Corridor 7-24

Southwest Oregon Connector Corridor

Corridor Review Table

Figure 3. Map of Conflict Areas in Vicinity of Corridor 7-24

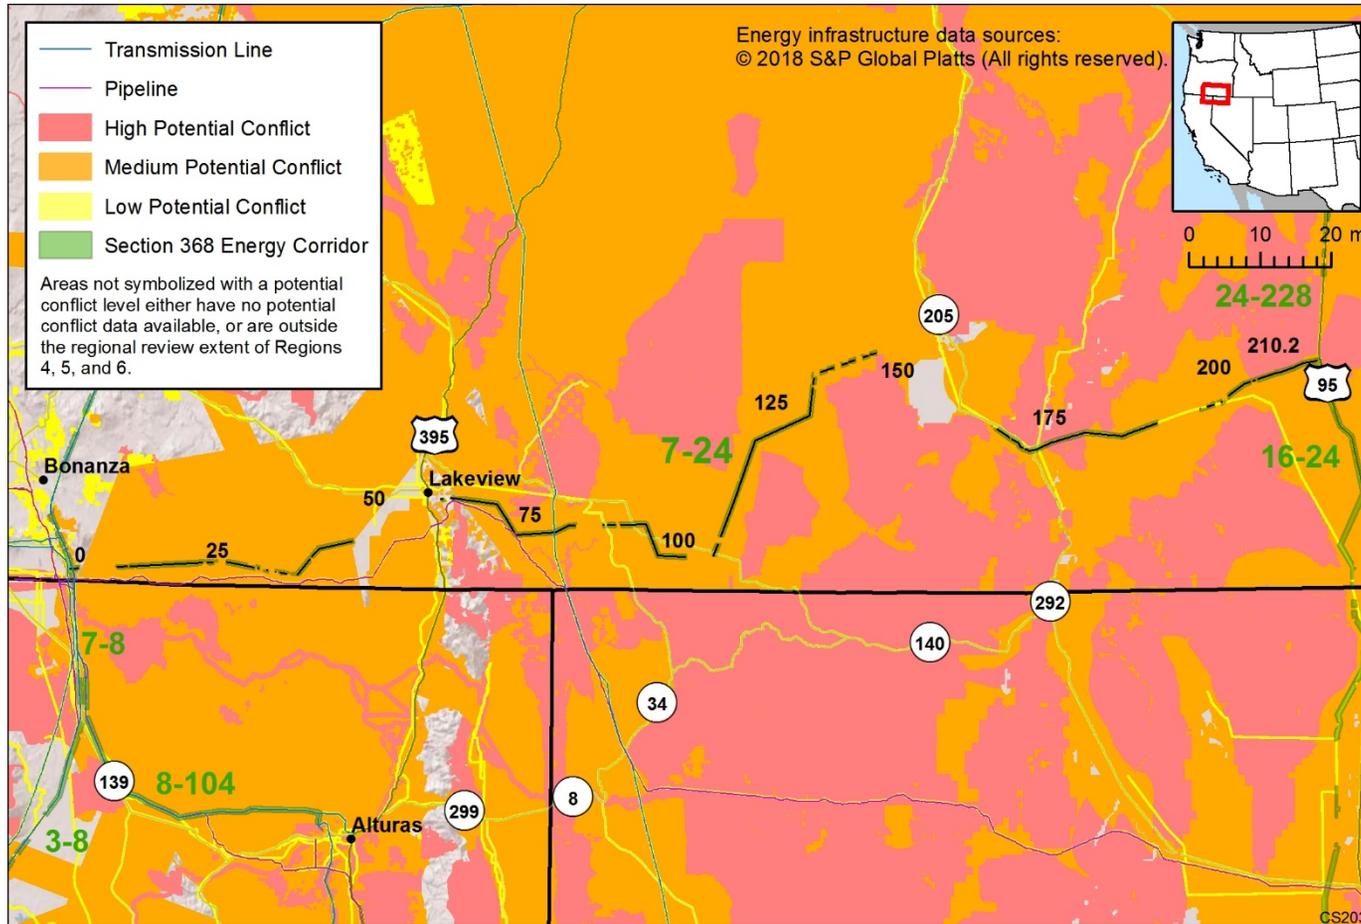
Figure 3 reflects a comprehensive resource conflict assessment developed to enable the Agencies and stakeholders to visualize a corridor’s proximity to environmentally sensitive areas and to evaluate options for routes with lower potential conflict. The potential conflict assessment (low, medium, high) shown in the figure is based on [criteria](#) found on the WVEC Information Center at www.corridoreis.anl.gov. To meet the intent of the Energy Policy Act and the Settlement Agreement siting principles, corridors may be located in areas where there is potentially high resource conflict; however, where feasible, opportunity for corridor revisions should be identified in areas with potentially lower conflict.
